ORDINANCE AMENDING SUBDIVISION REGULATIONS FOR HOUSTON COUNTY, ALABAMA

NOW, THEREFORE, BE IT RESOLVED AND, SEPARATELY AND SEVERALLY, ORDAINED BY THE HOUSTON COUNTY COMMISSION that Houston County, by and through the Houston County Commission, amends the Subdivision Regulations for Houston County, Alabama, as revised on June 23, 2008, as follows:

STANDARD SUBDIVISION TYPICAL SECTION

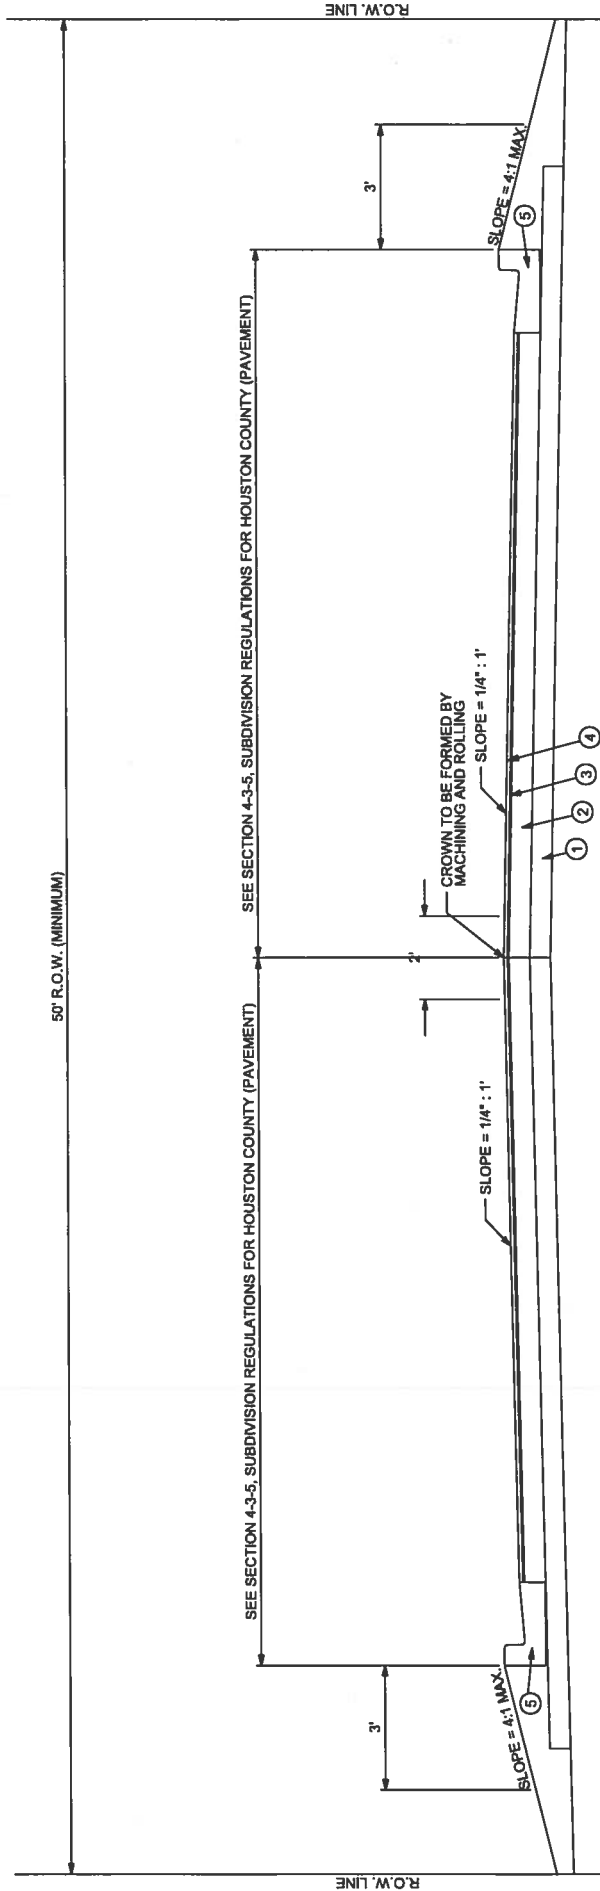
7. The Appendix on Page 33 of the Subdivision Regulations for Houston County, Alabama, as revised on June 23, 2008, is amended to the document entitled Appendix – 1 Standard Subdivision Typical Section, which is attached below.

CONCRETE CURB, TYPE (M-2) (ALDOT, SPECIAL AND STANDARD
HIGHWAY DRAWINGS, INDEX NO. 730)
SKETCHES OF CURBS AND GUTTER
TO BE PLACED WITH AUTOMATIC
CURB AND GUTTER MACHINES

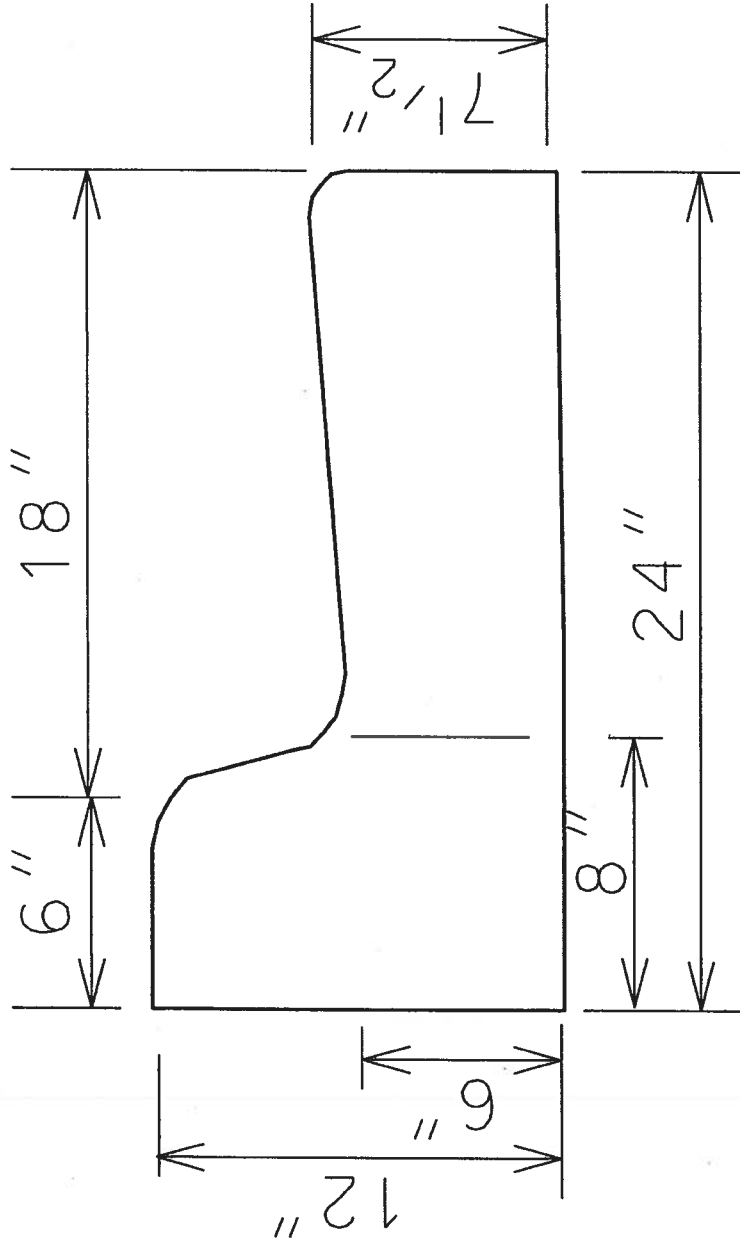
4. Section 4-3-6 **Curbs and Gutters** is Amended as follows: Concrete curbs shall meet the requirements for concrete curbs, Type "M-2" as set forth in the current Alabama Department of Transportation Standard Specifications for Highway Construction. All curbs and gutters shall be placed using an automatic curb and gutter machine. [Drawing included in the appendix]

8. The Appendix on Page 34 of the Subdivision Regulations for Houston County, Alabama, as revised on June 23, 2008, is amended to the document entitled Appendix – 2 Concrete Curb, Type (M-2) (ALDOT, Special and Standard Highway Drawings, Index No. 730) Sketches of Curbs and Gutter to be Placed with Automatic Curb and Gutter Machines, which is attached below.
9. An appendix is hereby added as Appendix – 3 Rural Subdivision Typical Section, which is attached below.
